# MultiPlus-II/EasySolar-II/Quattro-II Current Sense socket issue

Tech note – December 2021 - rev 3

Picture left showing incorrect data on (CC)GX and the VRM Dashboard.

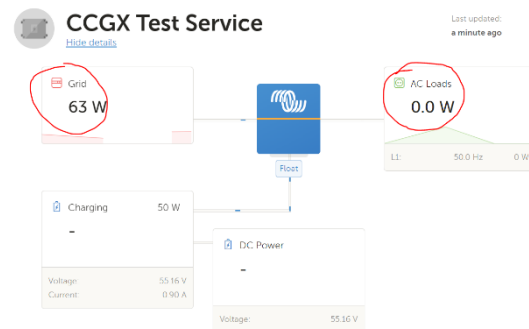
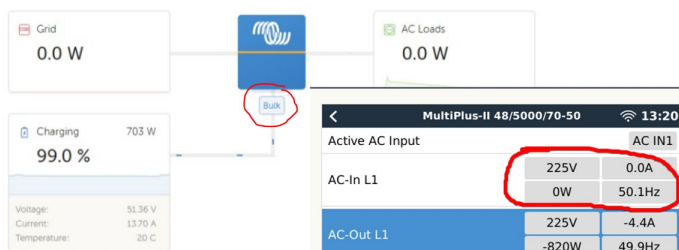
And lastly, in all above mentioned cases the real power from/to the grid will have no relation with the power displayed on the GX, VRM Portal, VictronConnect App or VEConfigure. The displayed power will likely (but not necessarily) stay at 0 W and 0 Amps.

Picture right showing 0.0W AC Loads and 63W consumed power from the grid. In reality a 600W load is connected.

To fix the contact, first switch the unit off and then briefly insert a 3.5mm jack plug (standard old style headphone plug) in the connector. Remove and re-insert the jack plug a few times to clear the issue. Finally, remove the jack plug and switch the unit back on. The problem is now resolved.
